Community Solar Project Interconnection
Tier 2 Community Solar Project Review

("Applicant")
OCS019

Proposed Interconnection
On PacifiCorp's Existing
Circuit 5L1 out of Beatty substation near 42°26'26.9"N,
121°16'23.8"W

May 22, 2020

Figure 1: System One Line Diagram

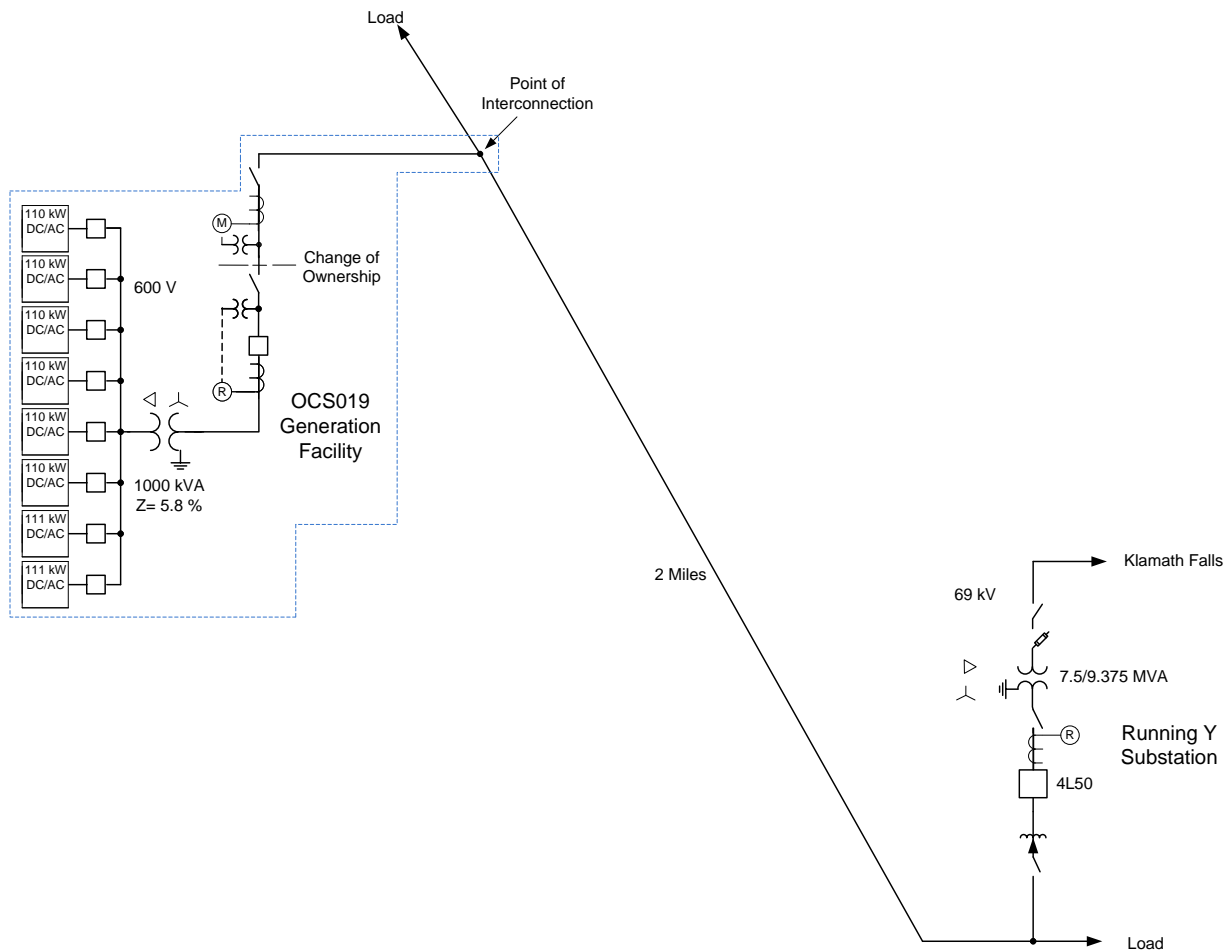
The proposed Community Solar Project is to be interconnected to the Public Utility’s distribution circuit 4L50 out of Running Y substation via a new 20.8 kV primary meter. The Point of Interconnection is expected to be at mapstring 01438008 facility point 0095001 near 42°16'16.70"N, 121°53'4.01"W. Figure 1 below is a one-line diagram that illustrates the interconnection of the proposed generating facility to the Public Utility’s system.
